GE Consumer & Industrial Service Bulletin

REFRIGERATOR
CENTER HINGE

REF 14-09

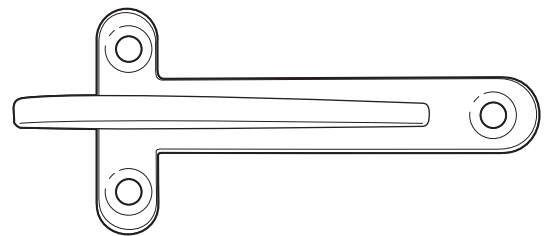
On some Stainless Steel units, reversal of the door swing from RH to LH will result in interference of the fresh food door end cap with the center hinge. In some cases, this will prevent the door from opening completely.

Note squared edges and bump in part on current part versus replacement part.

CURRENT PART: WR13X10317

NEW PART: WR13X10144

Replace current center hinge with new part, WR13X10144.
